REPORT TO PLANNING COMMISSION

APPLICATION NUMBER: PC-2024-03

APPLICATION NAME: 2880 ARNOLD TENBROOK (SITE PLAN AND TREE PRESERVATION)

APPLICANT'S REQUEST: A request for a Site Plan Review and Tree Preservation Waiver for an Industrial Building, within the "M-2" Industrial District, as provided in the Arnold Zoning Ordinance.

FIGURE 2 : PROPOSED SITE PLAN

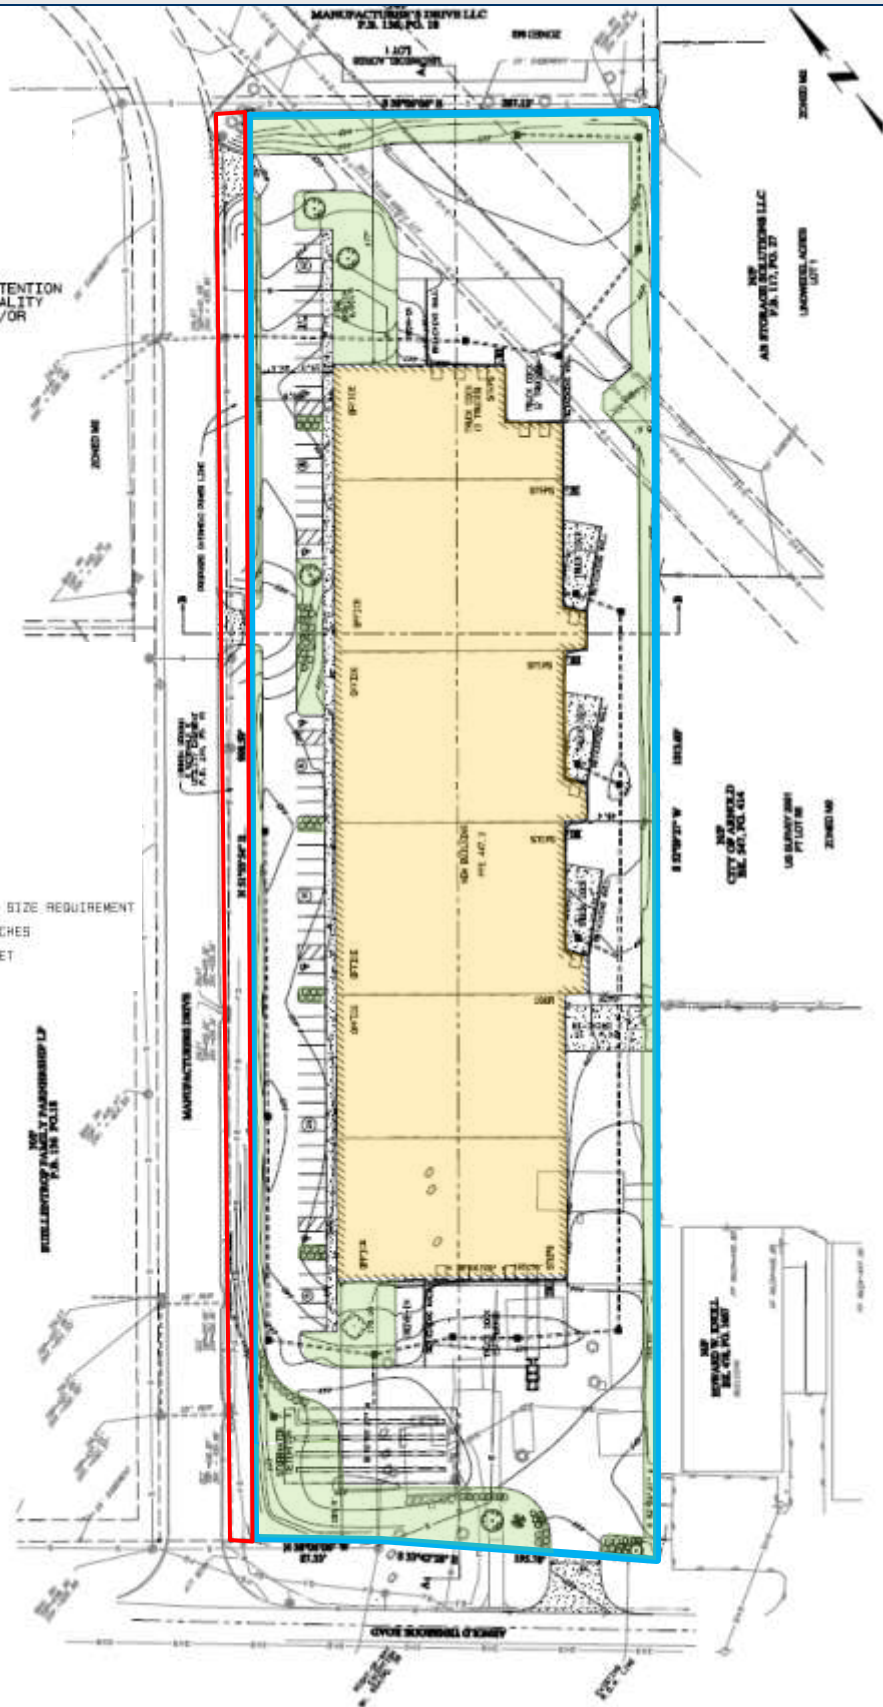
The total parking required uses shall provide 1 off-street parking space for every 2 employees or 1 space for 300 square feet of gross floor area, plus 1 parking space for every vehicle used in the operation of the use and normally placed on the lot. The calculated minimum of 24 parking spaces, and 4 off street loading areas based on the number of employee and building size. The minimums are exceeded, and the plan shows 52 standard dimensions parking spaces, 15 loading spaces, 5 ADA spaces with the required 24-foot wide access aisles.

The Public Works Director commented for the requirement for sidewalks along both Arnold Tenbrook and Manufacturers. As part of the development and new building permit for a parcel (per Section 800.680), sidewalks shall be required. Further, the City can request sidewalk or pedestrian facilities as indicated within City Plans, which includes the City of Arnold, Missouri Bicycle and Pedestrian Master Plan dated March 2022.

However, the 20-foot wide strip along Manufacturers Dr is under different ownership and is common ground for Tenbrook Industrial Subdivision. The subject parcel is not part of the subdivision and the limits of the parcel do not legally front along Manufacturers Dr. To require the parcel owner to construct sidewalks on another private property is not within the requirements of City Code. However, Staff notes that in past industrial developments, sidewalks were not required; there are no sidewalks along the entirety of Manufacturers Dr to connect to at this time. Since there is not yet a detailed construction plan by the City for this developer to follow, as in previous developments, it has been acceptable to make a contribution in lieu of construction. This is Staff's recommendation and included as a condition of the approval that the applicant make a contribution to Arnold's sidewalk fund. A monetary contribution specific to the Pedestrian Plan will suffice in fulfilling the code requirement for sidewalks. The funds will be ear marked for Manufacturers Dr and will be used in conjunction with future Public Works projects when it is designed and constructed.

Any part of a lot area not used for buildings or other structures or for parking, loading, or accessways shall be landscaped with grass, ground cover, trees, shrubs, and pedestrian walks. The landscape as proposed meets the minimum requirements for number of trees and exceed the number of required shrubs as shown on page 5.

As a side note, the strip of Tenbrook Industrial Common ground (shown red on page 4-5), the evergreen trees along Manufacturers Drive are being removed due to utilities in the area and are located beyond the property limits. Staff requested to applicant that landscape plan be reviewed to include evergreen tree or shrub that would be appropriate to plant near utilities.

- 1. The Site Improvements shall be consistent with those approved by Planning Commission.**
- 2. The Building exterior materials and colors shall be consistent with those approved by Planning Commission.**
- 3. Should future exterior waste dumpsters be provided, they shall have an enclosure complimentary to the building.**
- 4. The landscape plan is to be reviewed to include evergreen tree or shrub that would be appropriate to plant near utilities. The applicant shall work with staff regarding any minor changes to the landscape plan.**
- 5. The applicant shall make a contribution in lieu of construction to the sidewalk fund (Re: City of Arnold, Missouri Bicycle and Pedestrian Master Plan, dated MARCH 2022).**
- 6. The Tree Preservation Appeal is approved for exclusively for this site plan.**
